SUBJECT: PINELAWN MEMORIAL PARK, NO. 52-044

RE: MAJOR RENOVATION AMENDMENT-PARKING AREA

**Re: Pinelawn Memorial Park and Arboretum (52044)
Requested Amendment to August 11, 2020 Approval**

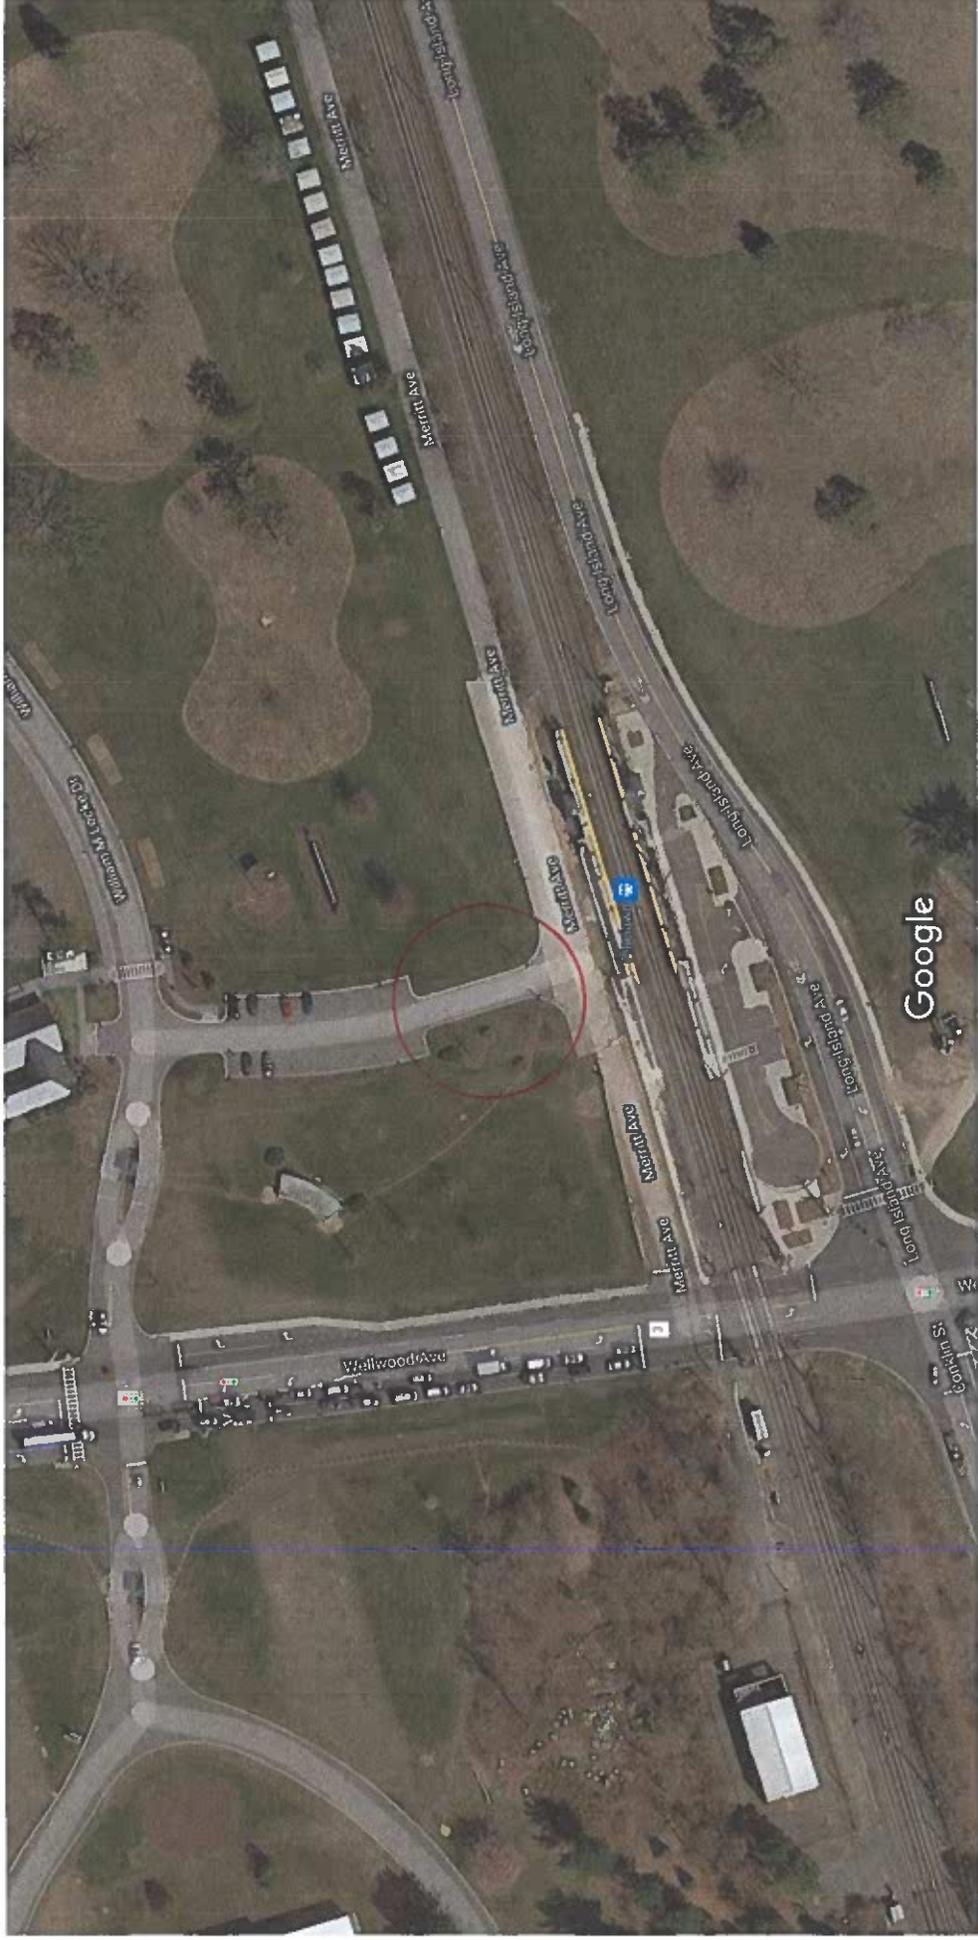
The proposed change involves the expansion of the existing guest parking lot connected to Merritt Avenue to add sixteen (16) spaces along with the additional curbing associated with the newly paved areas as well as new drainage. The drainage would be wholly within the parking area.

The Cemetery would also relocate two existing light poles to adequately cover the new area.

The area highlighted in yellow in the attached diagram indicates the subject area of the amendment. The area highlighted in blue is the approved project area. The attached pages provide the following:

Relocate Light Pole

New Drainage Inlet's
